Project: SECTION 96

TO AN EXISTING DWELLING AT 27B MACDONALD STREET, FRESHWATER

PROPOSED ALTERATIONS AND ADDITIONS

27/1/17 'A' - section 96(1A)

Dwg No. DA 4 A

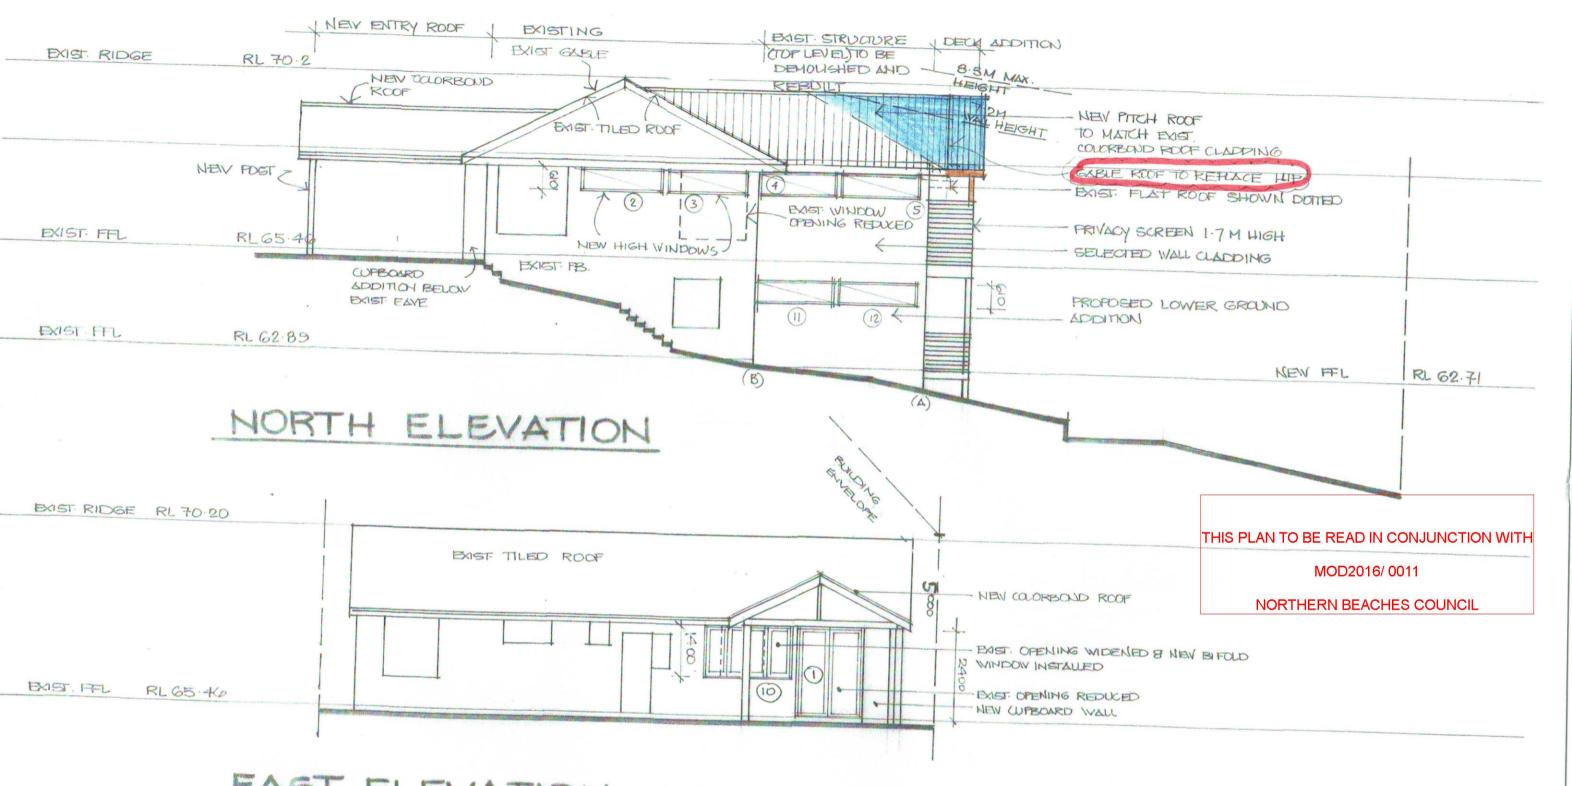
AMENDMENTS

New window to laundry - south wall New external stair from ground floor deck relocated South facing new hip roof to form a Gable end
